CITY OF CAMBRIDGE, MASSACHUSETTS

PLANNING BOARD

NOTICE OF DECISION

Case Number:	293
Address:	79 JFK Street
Zoning:	Residence C-3 / Harvard-Radcliffe-Lesley Institutional Use Overlay District
Applicant:	President and Fellows of Harvard College, c/o Harvard Planning & Project Management 1350 Massachusetts Avenue, Suite 573, Cambridge, MA 02138
Owner:	President and Fellows of Harvard College Massachusetts Hall, Cambridge, MA 02138
Application Date:	August 5, 2014
Date of Planning Board Public Hearing:	October 7, 2014 and continued to November 25, 2014
Date of Planning Board Decision:	November 25, 2014
Date of Filing Planning Board Decision:	January , 2015
Application:	Request for Project Review Special Permit (Section 19.20) to permit the construction of three institutional building additions and redevelopment of the courtyard at the Harvard Kennedy School Campus.
Decision:	GRANTED, with Conditions

GATEWAY ENTRY WITH PERMANENT GATE

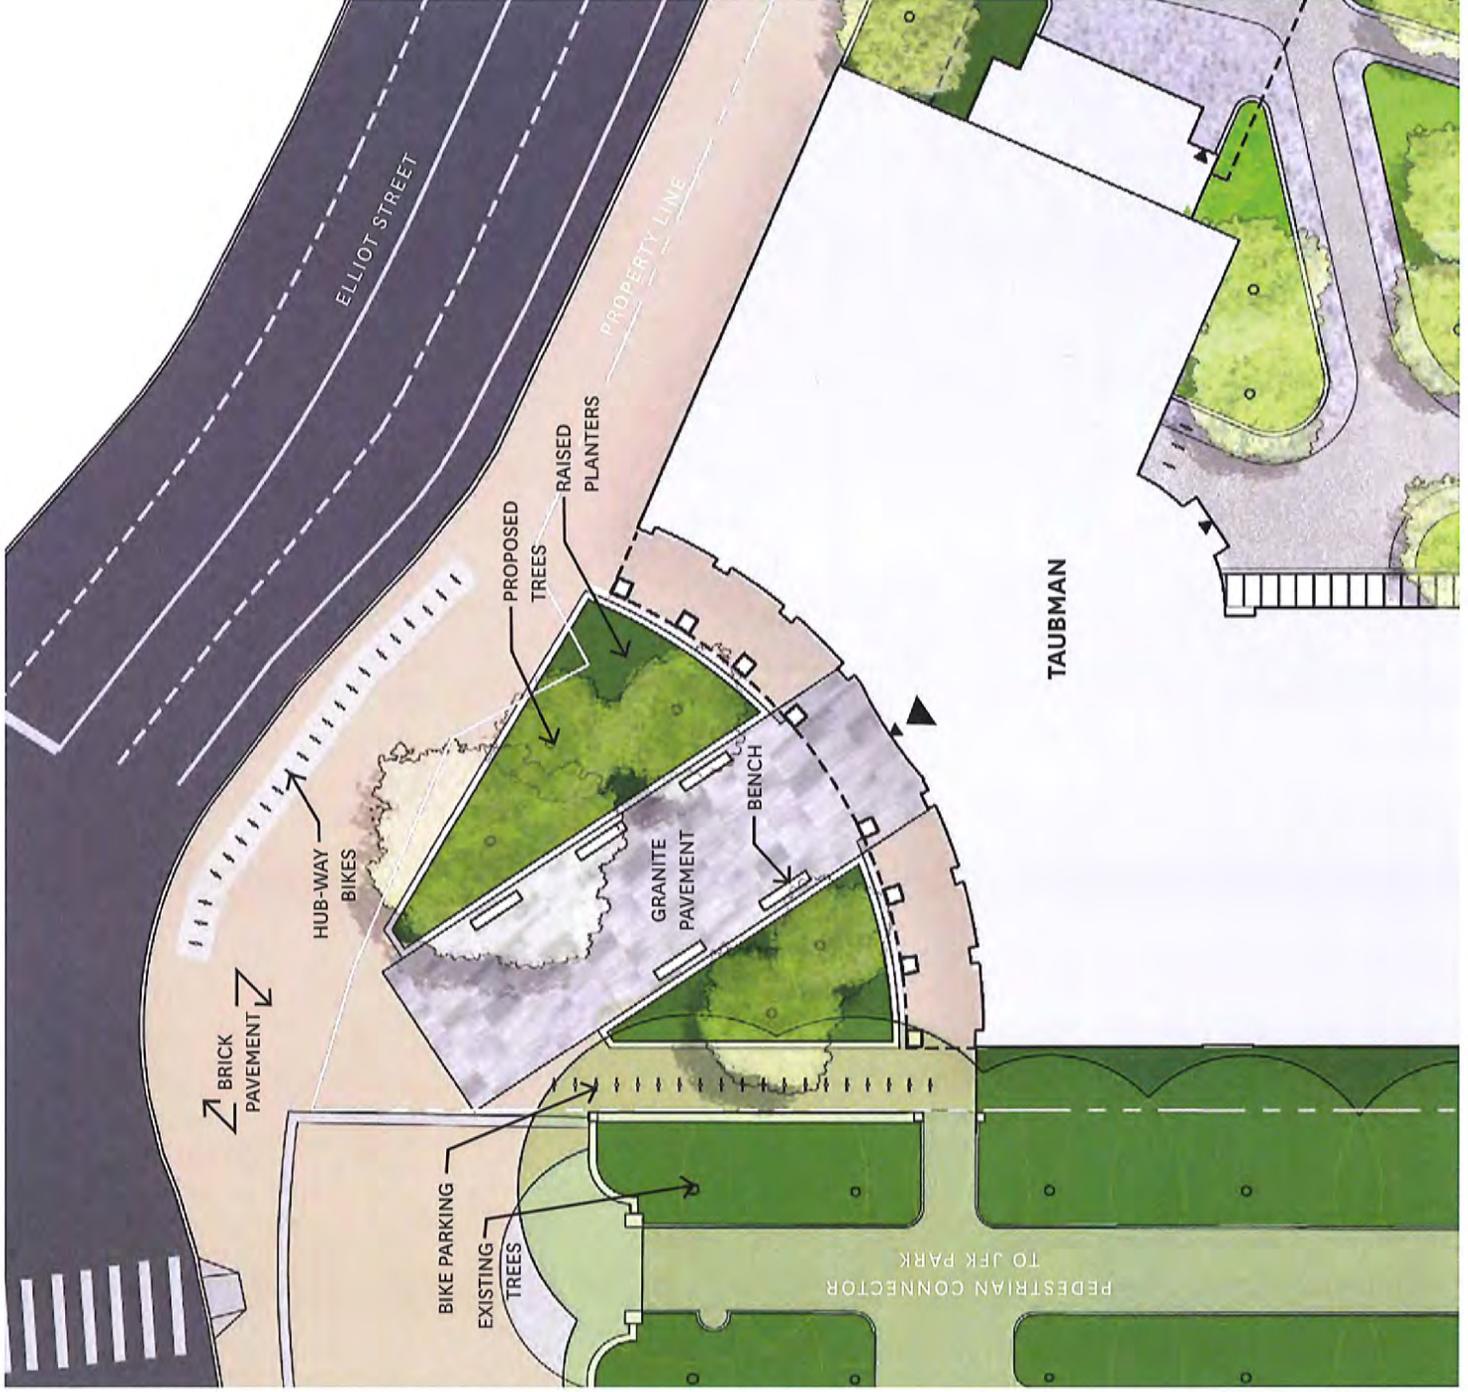
The Eliot Street entrance is intended to remain open 24/7 without any physical restrictions to access (See Attachment 6-1). The security bollards and screens proposed at this entrance will be used only when HKS is required to secure the campus at the directive of public safety officials. Based on campus operations history over the past two years, the existing entry gates at Eliot Street were closed an average of four hours on six occasions per year; a total of 24 hours per year.

Given the limited nature of its intended use, a security gate system that is modular and can be readily installed, removed and stored out of site when not in use, remains the preferred alternative. HKS has amended the design to incorporate features such as a black finish and a Harvard insignia that are consistent with the character of other Harvard gates (See Attachment 6-2).

LANDSCAPING PLANS

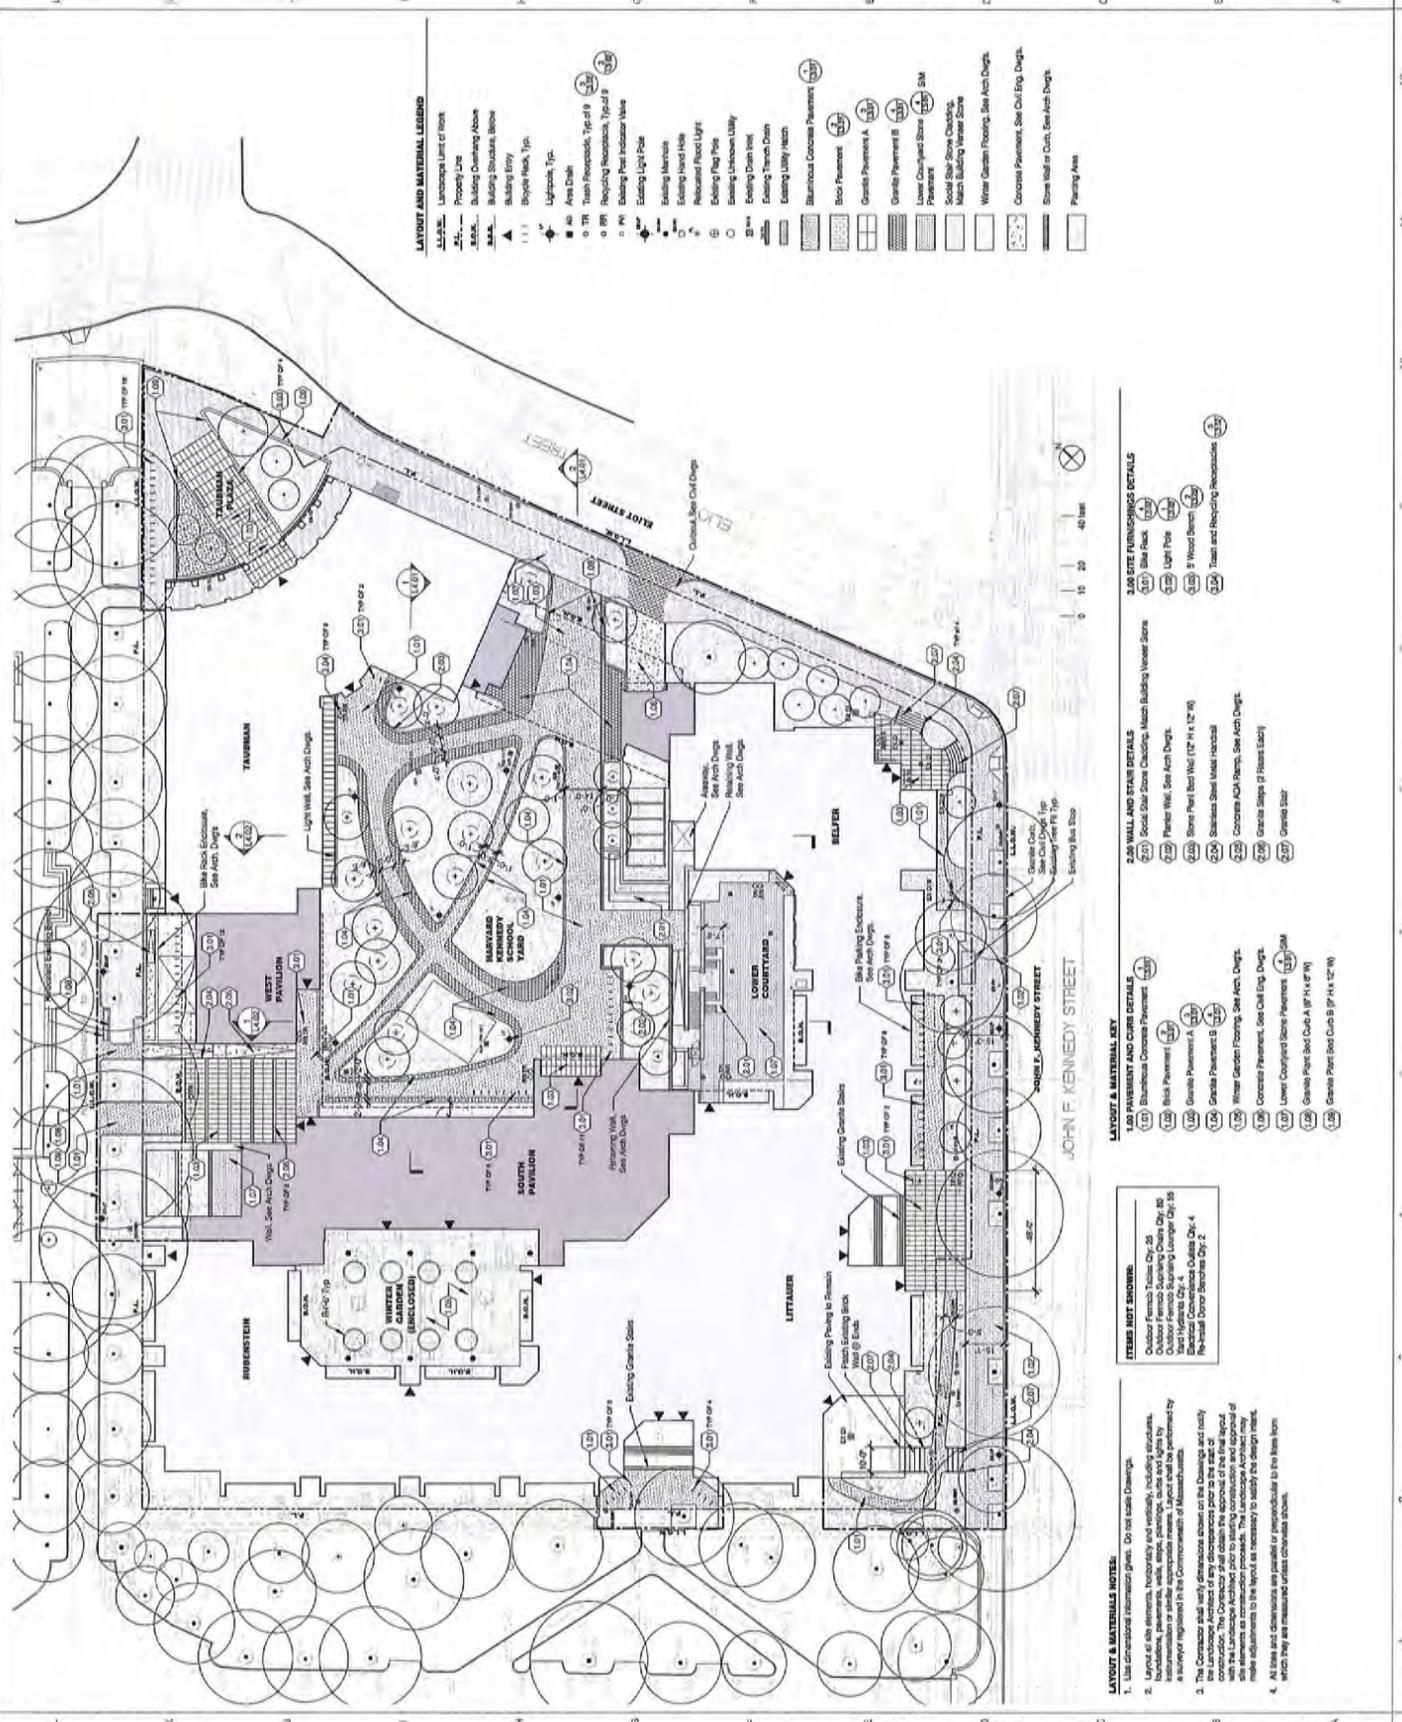
A more detailed landscaping plan is being provided that incorporates all of the modifications noted above (See Attachment 9).
